# Development Review Comments

October 4, 2023

PAM2023-00149

414 – 416 Hungerford Drive

**A0121**

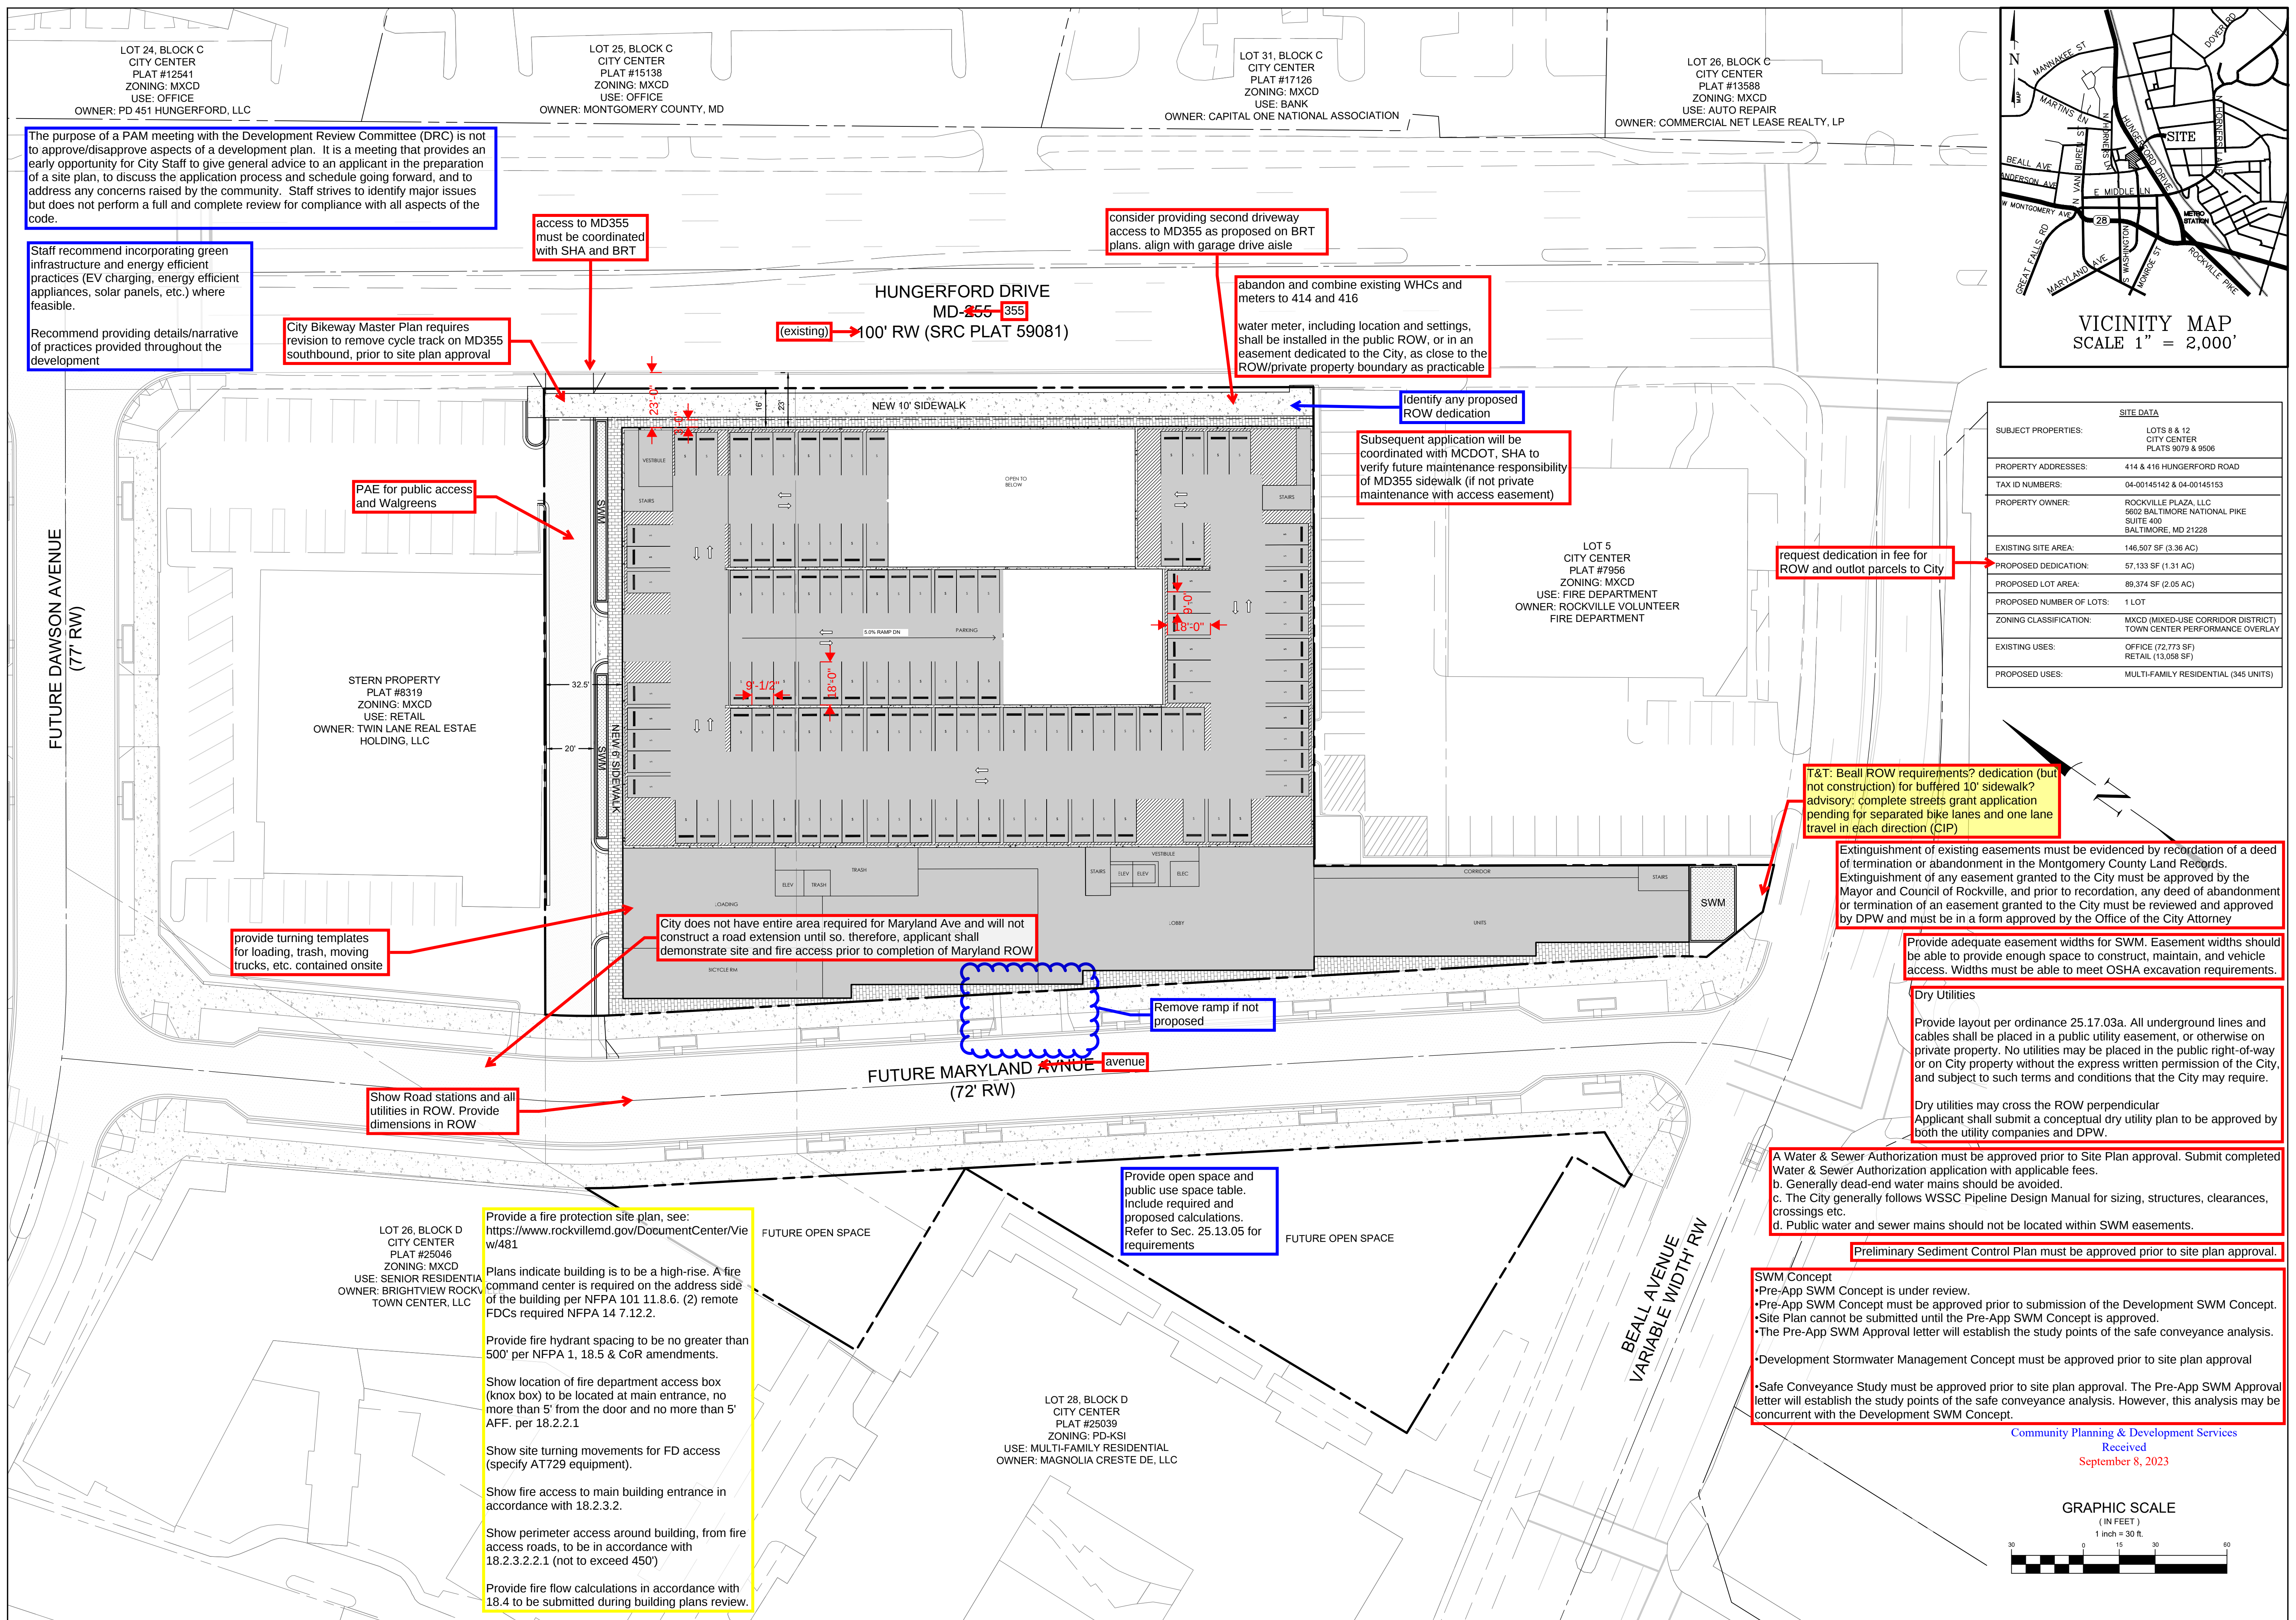
Add short-term and identify location in

plan. Revise  
long-term calculation.

Refer to Sec.  
25.16.09 for bicycle  
parking standards
